Metro West Joint Development Assessment Panel Agenda

Meeting Date and Time: 22 April 2020, 9:00am

Proposed Childcare Premises
Lots 456 & 17 (No. 77-83) Scarborough Beach Road, Mount Hawthorn

Approve DAP Application reference DAP/19/01674 and accompanying plans referenced as drawings S01 rev6, S02 rev6, S03 rev6, S04 rev4, S05 rev3 and landscape plans Revision F dated 27/03/2020 in accordance with Clause 68 of Schedule 2 (Deemed Provisions) of the *Planning and Development (Local Planning Schemes) Regulations 2015* and the provisions of the City of Vincent Local Planning Scheme No. 2, and pursuant to Clause 24(1) and 26 of the Metropolitan Region Scheme, subject to the following conditions:

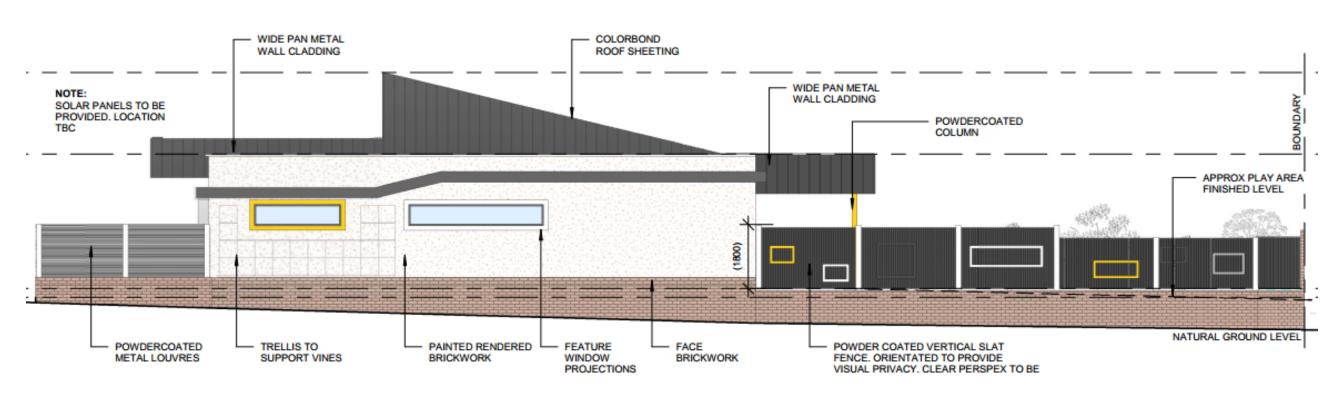
- The development interface with Scarborough Beach Road through the provision of awnings, major entry points, passive surveillance and activation of the streetscape.
- 2. The development interface with Imbros Lane to provide passive surveillance of the laneway;
- 3. The extent of onsite landscaping provided in the context of the relevant policy provisions;
- 4. Ensuring the car park design is highly functional and provides for safety of pedestrian movement; and
- 5. Further consideration of amenity impacts on surrounding properties

The proposed changes to improve the developments interface with Scarborough Beach Road included:

- 1. Relocation of the primary access point;
- 2. Providing a continuous awning extending the length of the development along Scarborough Beach Road;
- 3. Modified fencing to the outdoor play area to increase visual permeability;
- 4. Modified building materials and colours; and
- 5. Provision of a bench adjacent to the primary entry point.

2. DEVELOPMENT INTERFACE WITH IMBROS LANE

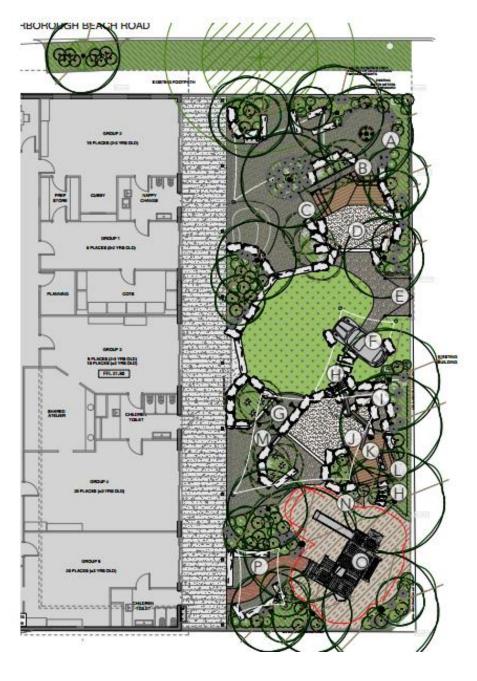
The proposed changes to improve the developments interface with Imbros Lane included:

- 1. Modified fencing to the outdoor play area to increase visual permeability;
- 2. Modified building materials and colours;
- 3. Provision of additional canopy cover along the frontage; and
- 4. Installation of trellis's to support vegetation growth along

3. EXTENT OF ONSITE LANDSCAPING

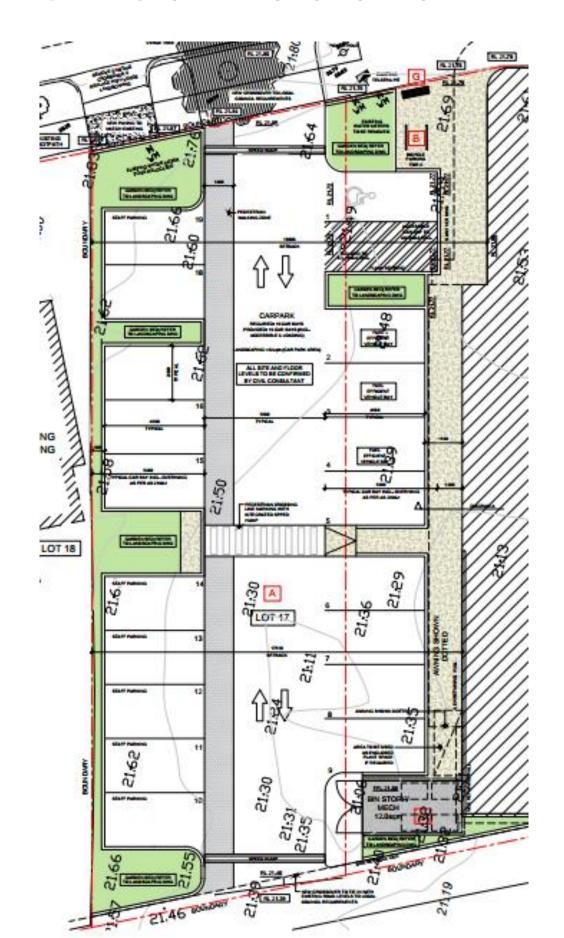
The proposed changes to improve the provision of landscaping included:

- 1. Increased deep soil area to 10% of the site;
- Implemented real grass to reduce heat impact and improve soil permeability; and
- 3. Increase to the proposed canopy coverage;
